# United States Department of the Interior

3482  
U-50722  
(UT-065c)

Re: Minor Modification to Soldier Canyon Mine - Rock Partings in the 2nd West Section

SOLDIER CREEK COAL COMPANY  
SOLDIER CANYON MINE  
ROCK CANYON SEAM  
APPROVED MINE MAP

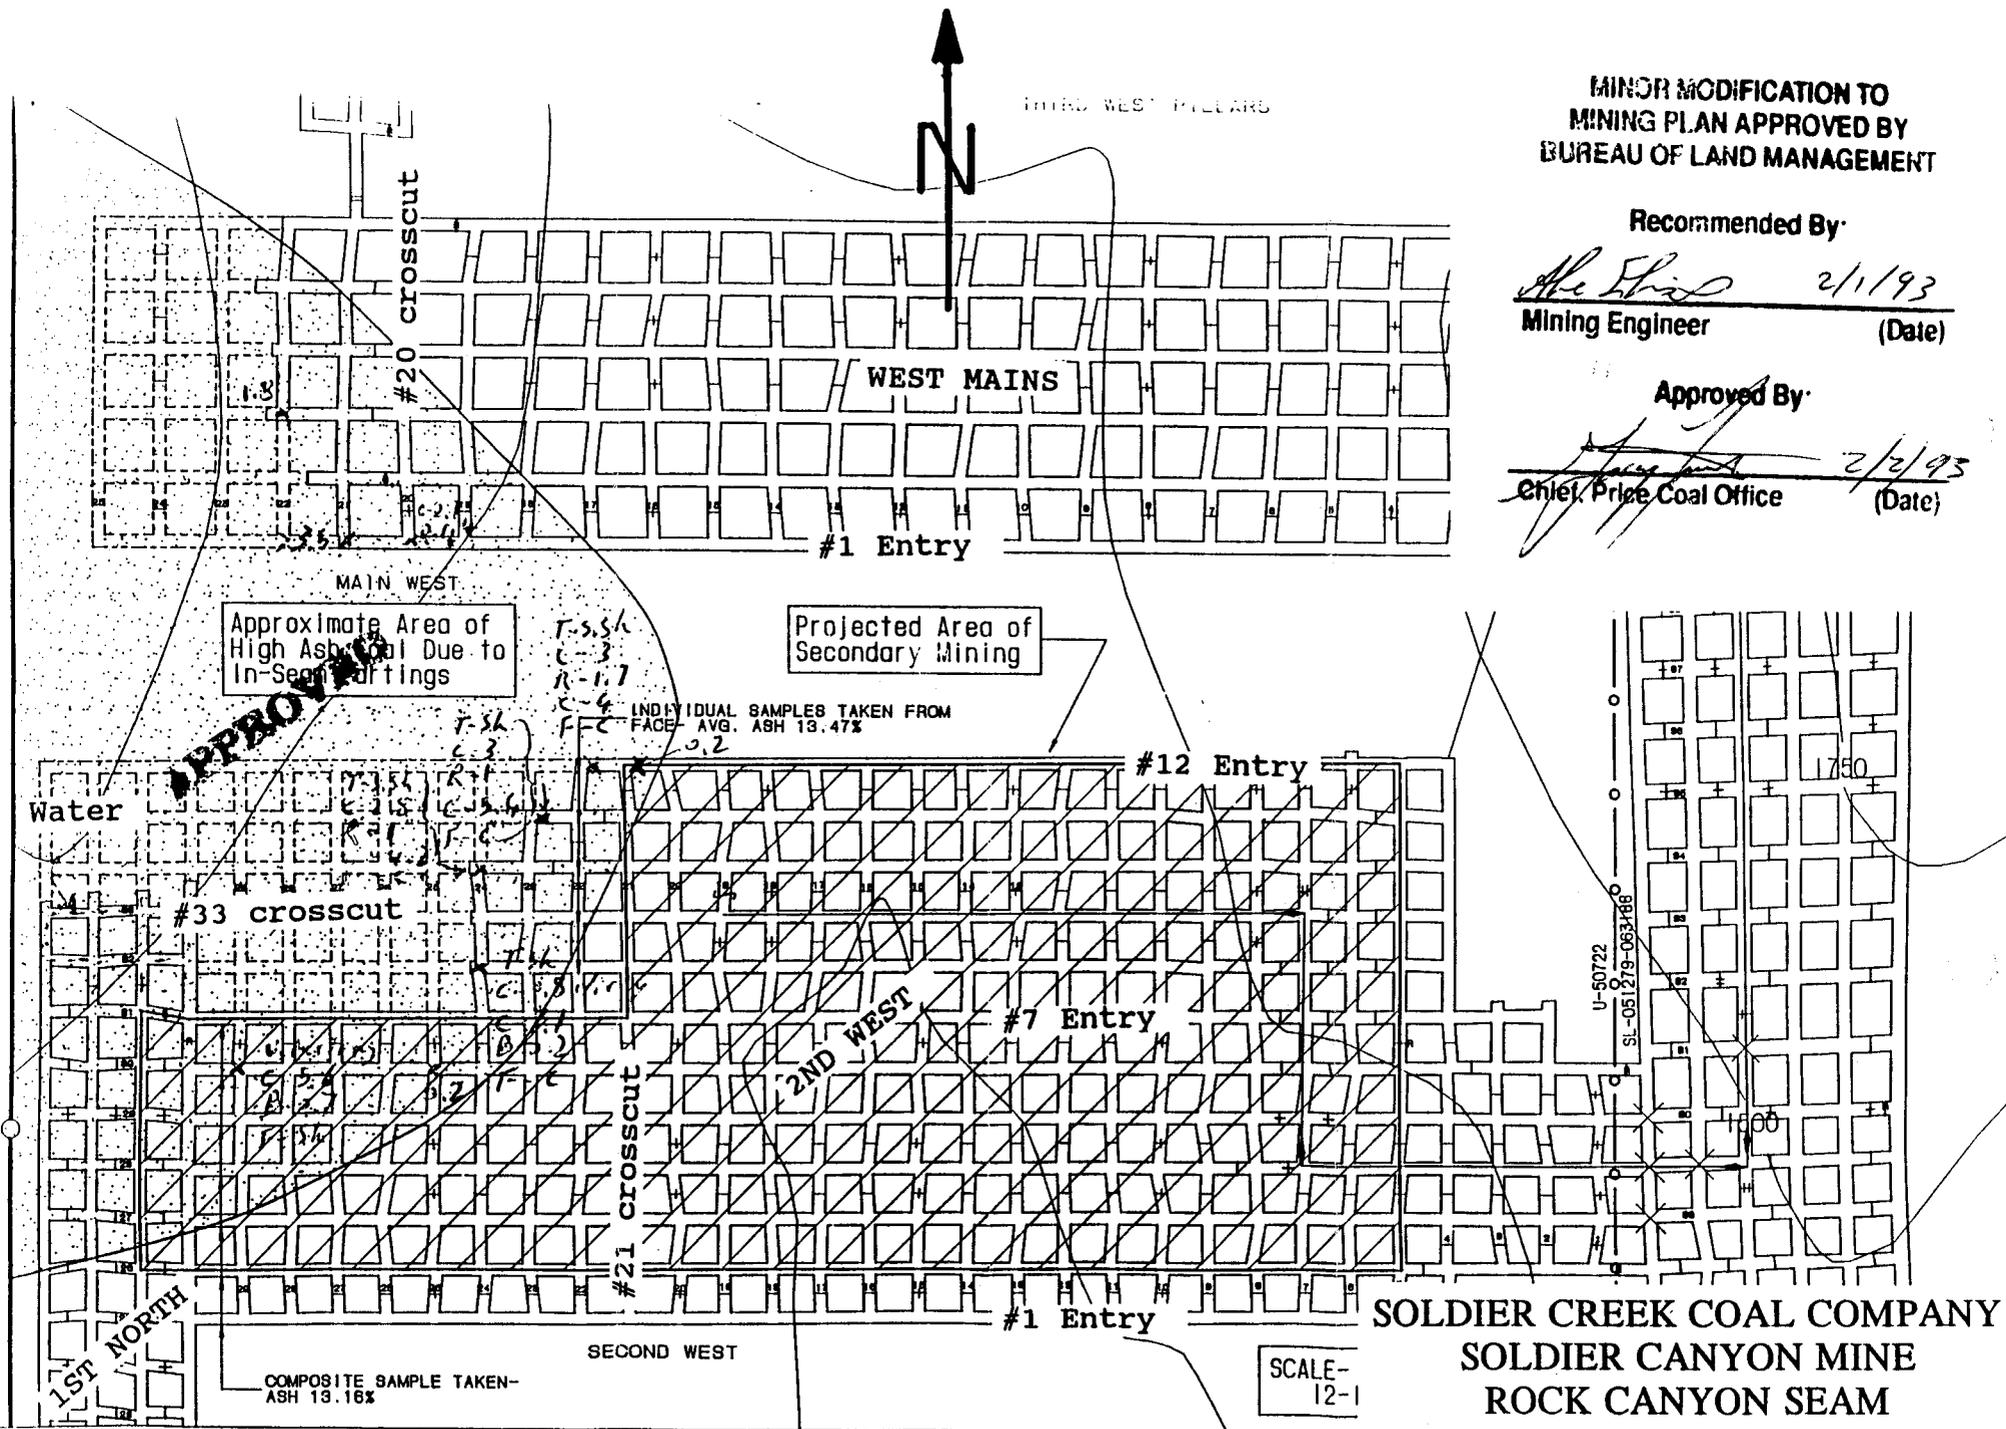
The approved mining plan was to develop 12 entries in the 2nd West section and connect the developed entries to the 1st North section. SCCC developed 7 entries as planned and is now proposing to stop developing the remaining 5 entries at #22 crosscut, retreat mine the developed pillars and abandon the block of coal located to the north of #7 entry and to the west of #21 crosscut (see enclosure).

Soldier Creek's justification for the mine plan change are two rock partings in the upper and lower portions of the seam which dilute the coal and increase the ash content to unacceptable limits. The partings are very hard to mine and vary in thickness between 1 foot and in excess of 3.5 feet at some locations.

SCCC's contractual limits for ash content are 11% on a 5 train average or 12% on a single train basis. Independent calculations show that mining two inches of rock parting within a ten foot coal seam, in addition to the in-seam ash content, can dilute the production to an unacceptable level of more than 12% ash. The company has no wash facility and coal is produced from one section only; therefore, mining the rock partings will dilute the coal and increase the ash content to the unacceptable contractual limits.

Under the present circumstances, the BLM has authorized SCCC to discontinue developing the remaining five entries at #22 crosscut and start retreat mining the developed pillars. In addition, SCCC may abandon the block of coal located to the north of #7 entry and to the west of #21 crosscut. This confirms the verbal approval given to Soldier Creek Mine personnel on December 17, 1992. An estimated 40,000 tons of coal reserves are now deemed unrecoverable.

The BLM has determined that the mine plan change is in compliance with the Mineral Leasing Act of 1920, as amended, the regulations at 43 CFR 3480, the lease terms and stipulations, and will achieve maximum economic recovery of the Federal coal. A copy of the approved mine map is enclosed.
